INVITATION TO TENDER “ITT” NO. PS20170312  
CONTRACTOR FOR MARPOLE PLACE RESTORATION

QUESTIONS AND ANSWERS NO. 2

ISSUED ON March 29, 2017

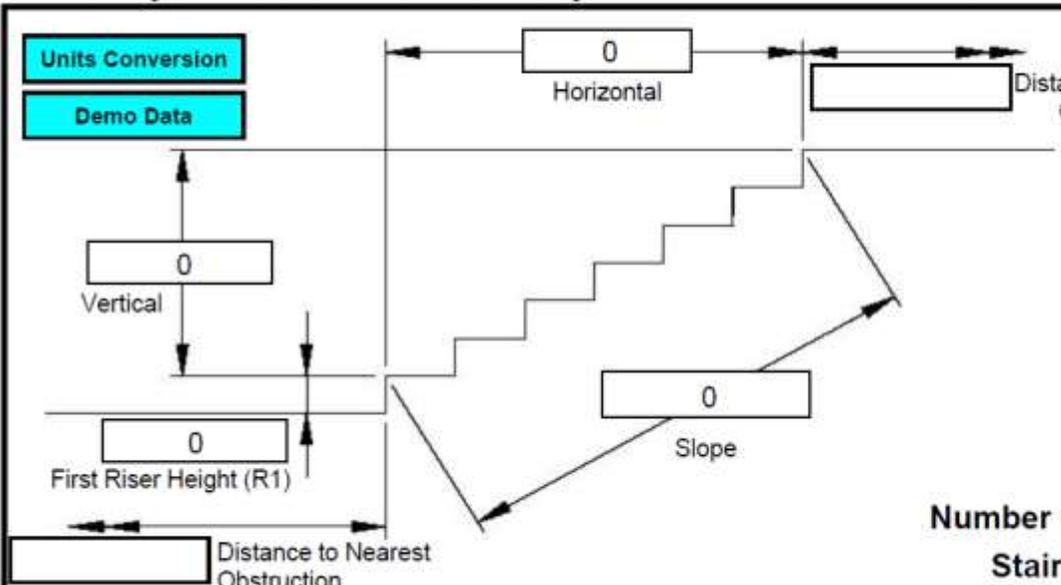
Q2.9 Please see below the comments from a specialty lift contractor:

*I'll also need actual individual rise, run and slope stair dimensions. A5.8 does not provide this. A2.5 shows that the lift and the elevator share a safety zone...this is not allowed by code.*

*See below for dimensions needed to quote this lift.*

*The architect will have to provide this info in order to properly quote. I have also attached the design guide for this lift.*

<b>A2.9</b>	<p>Please see architectural addendum (ADD 2), drawing A5.8 for clarification.</p> <p>Also note, the current layout as drawn has been recognized as an encroachment and a variance agreement is in place.</p>
-------------	--
